Title: Advisory Committee on Reactor Safeguards

Date: Thursday, December 3, 2009

License renewal application for the Prairie Island Nuclear Generating Plants, Units 1 and 2;

Draft final Regulatory Guide 1.205, "Risk-informed, Performance-Based Fire Protection for Existing Light-water Nuclear Power Plants," and draft final Standard Review Plan, Section 9.5.1.2, "Risk-informed Performance-based Fire Protection";

Refueling Cavity Leakage Root Cause Evaluation

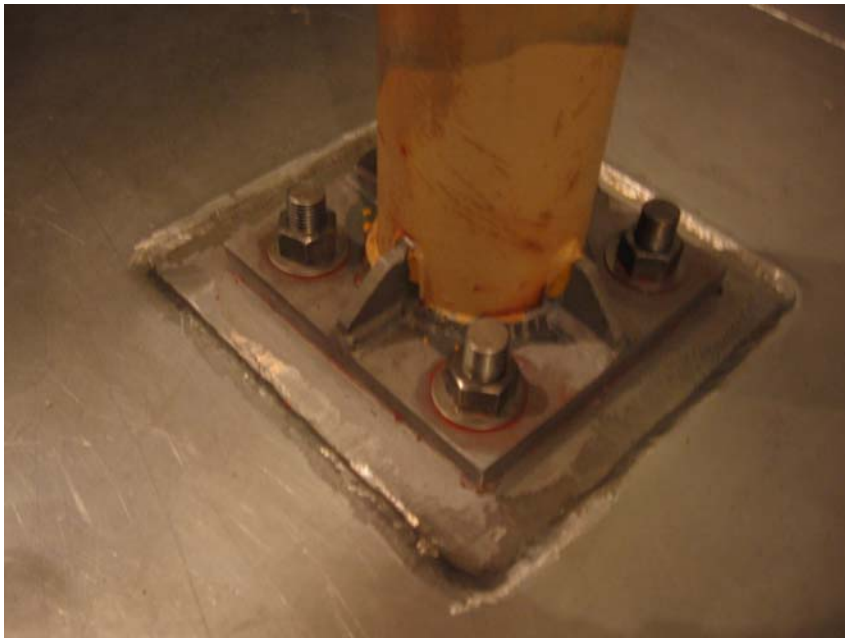
7 What's shown on this slide is a typical
8 reactor vessel internal stand support as well as an
9 RCC change fixture support. The bolts which you'll
10 see coming up through there to attach those stands
11 actually come through the embedment plates.

12 The red material that you see in the
13 picture is the caulk that we've been utilizing to seal
14 between the nuts and between the embedment and base
15 plates. That was a material that we put on at the
16 beginning of the outage and then remove at the end of
17 the outage.

Original Embedment Plate Configuration

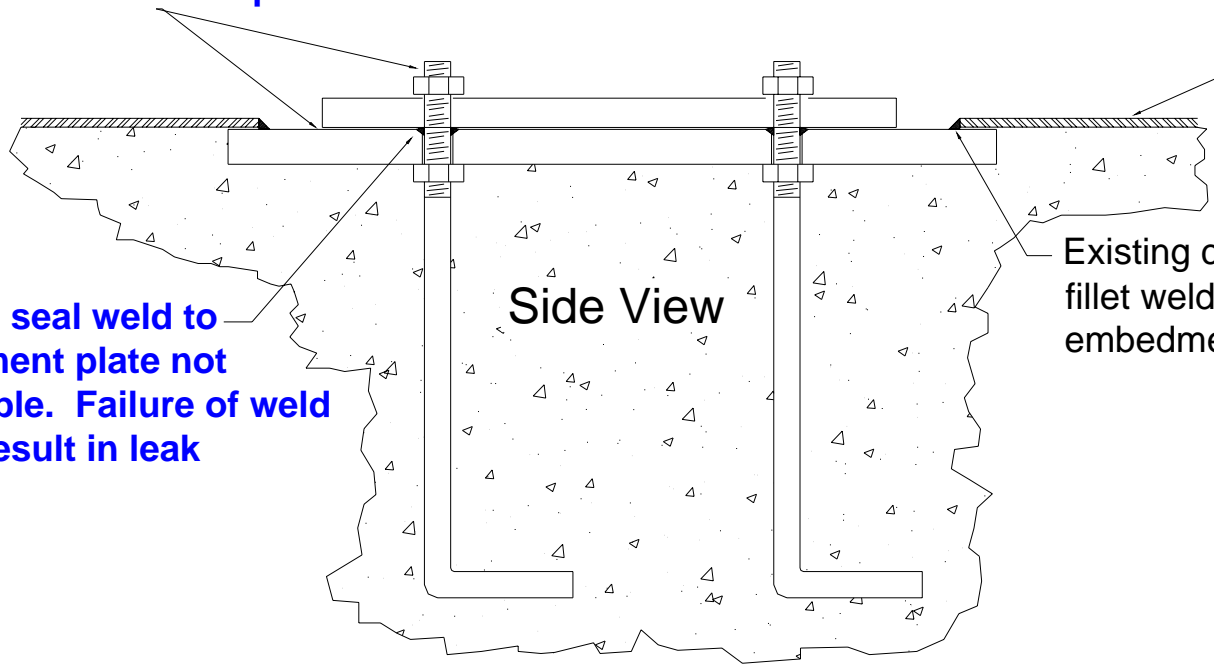
24 MR. SKOYEN: The original embedment plate
25 construction is show on this picture, and I'd like to

Potential leak path along
threads or under baseplate

Underground Medium Voltage Cables Manhole Inspection Interval

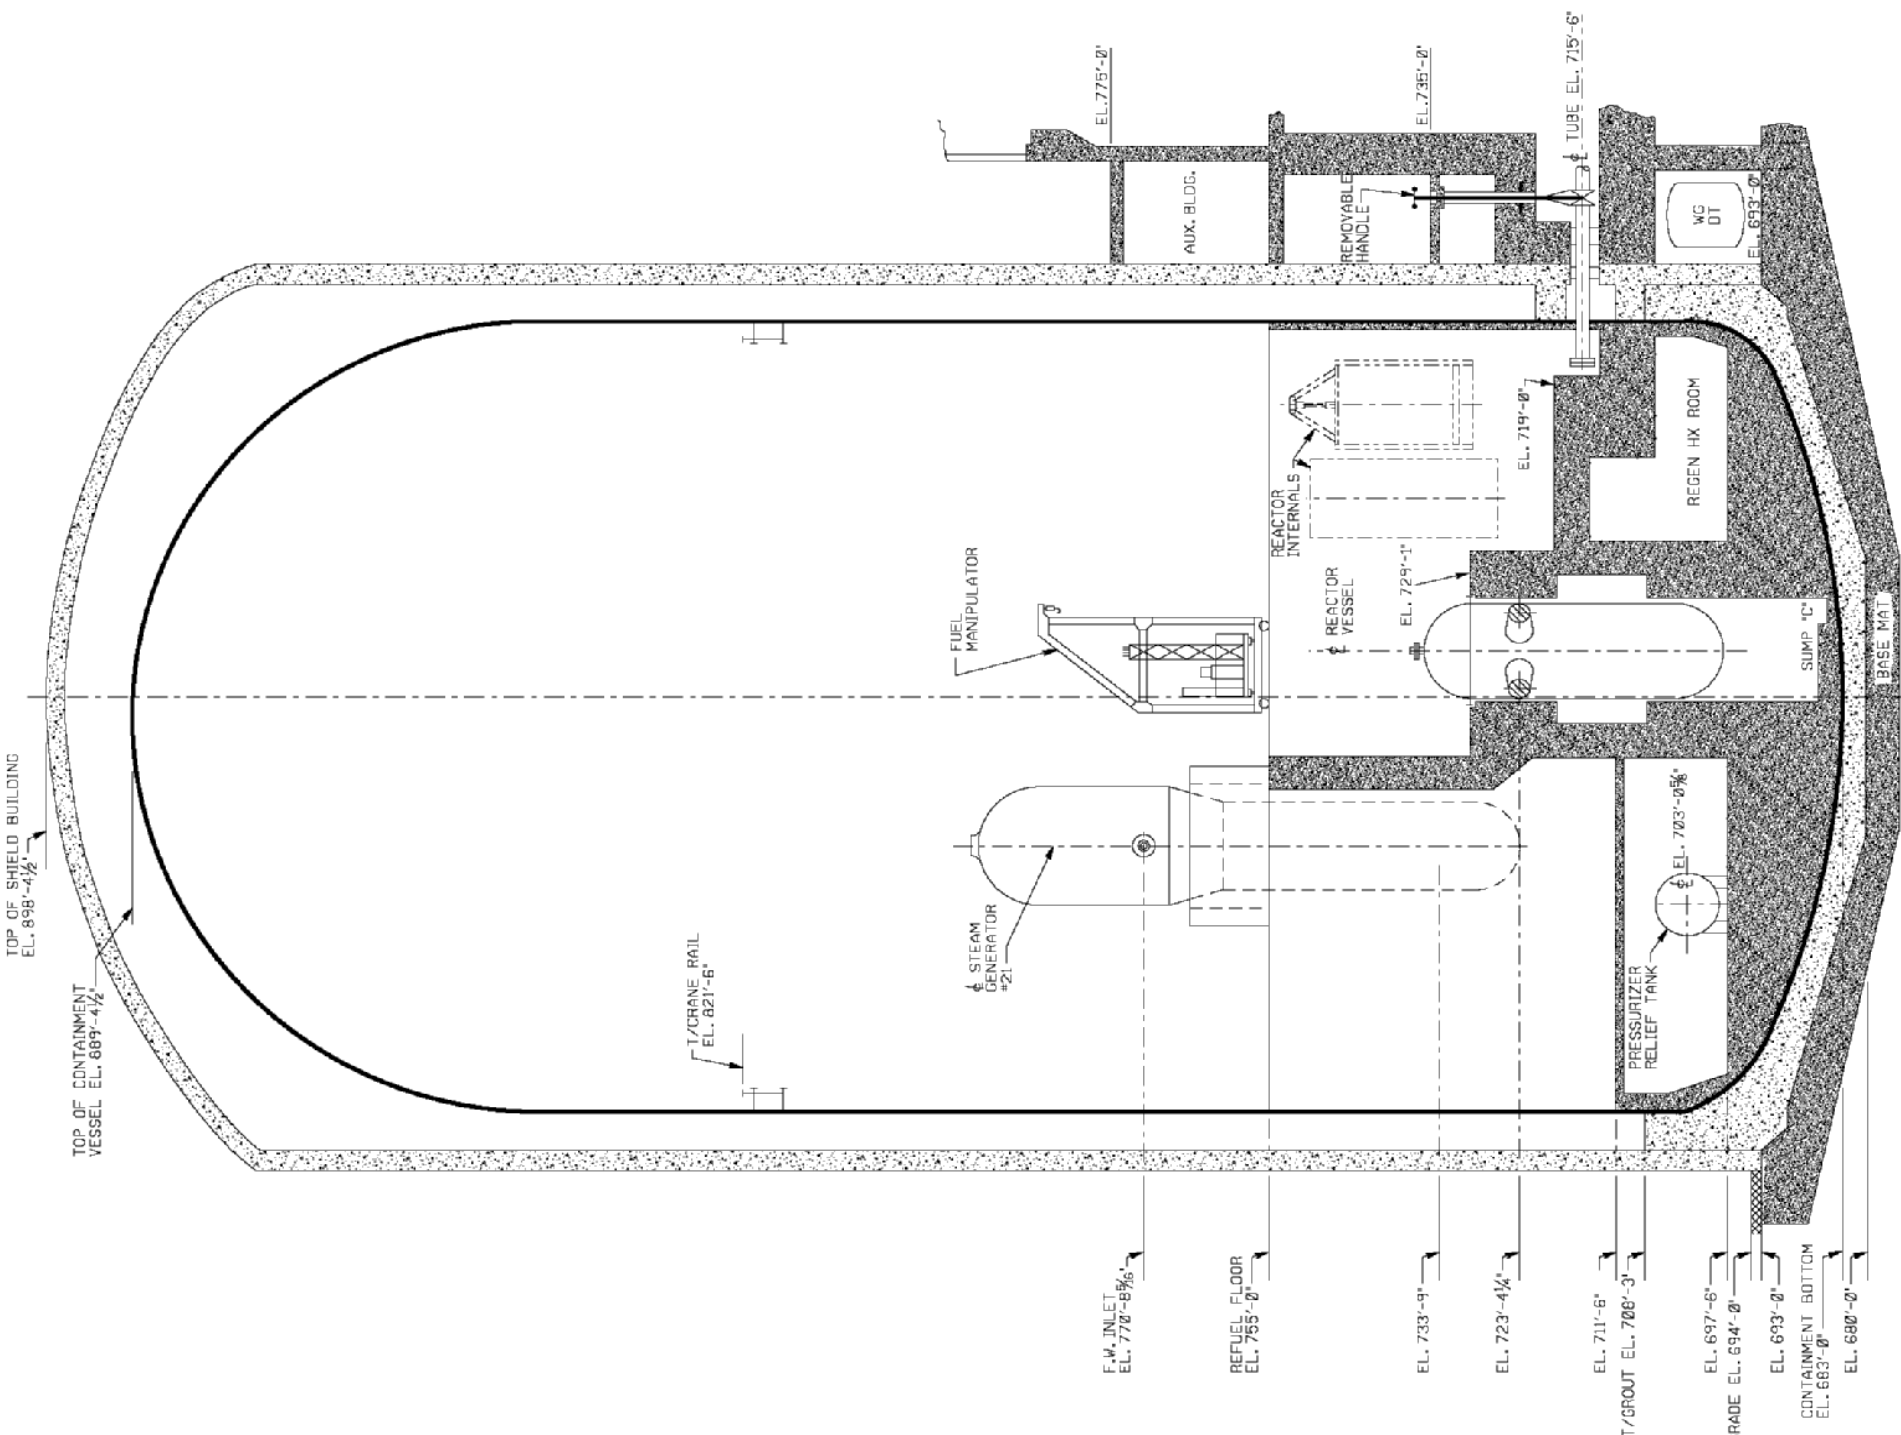
14 MEMBER STETKAR: Gene, I just want to make
15 sure I've got the history straight. You had some
16 cable failures. You rerouted the cables in question.
17 The manhole, the subject manhole that we're looking
18 at on the screen right now, is part of that new
19 routing path.

21 MEMBER STETKAR: That's correct? And you
22 mentioned earlier that you had performed five
23 inspections since September of 2007 and discovered no
24 signs of water intrusion. That's of this manhole.

20 MR. ECKHOLT: That's correct.

25 MR. ECKHOLT: That's correct.

Previously Approved RAs

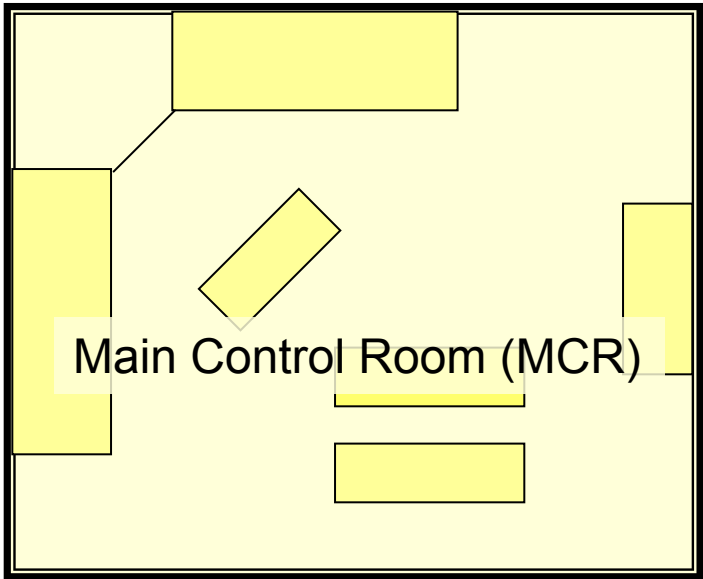
- Public Comment
 - Previously approved recovery actions should be deemed to meet the deterministic requirements of NFPA 805, Section 4.2.3

- NRC Response
 - Comment not incorporated because such guidance would be contrary to the requirements in NFPA 805
 - Additional risk (Δ CDF; Δ LERF) of certain recovery actions must be evaluated
 - The risk is acceptable based on previous approval*
 - This additional risk is considered when evaluating the acceptability of other, proposed risk contributions when using the performance-based approach

Primary Control Station

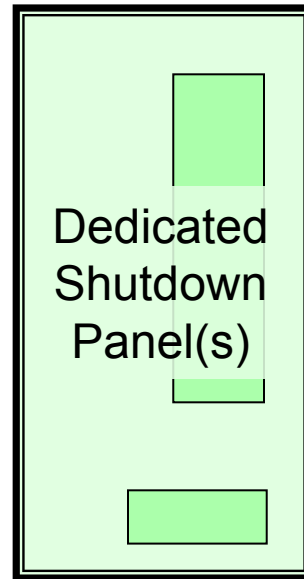
- Public Comment
 - The benefit of defining *primary control station* is not evident
- ACRS Subcommittee Discussion
 - Draft definition of primary control station could lead to undesired classification of recovery actions
- NRC Response
 - Clarified the definition of primary control station to allow “carry over” (subject to certain conditions) of approved manual actions (next slide)
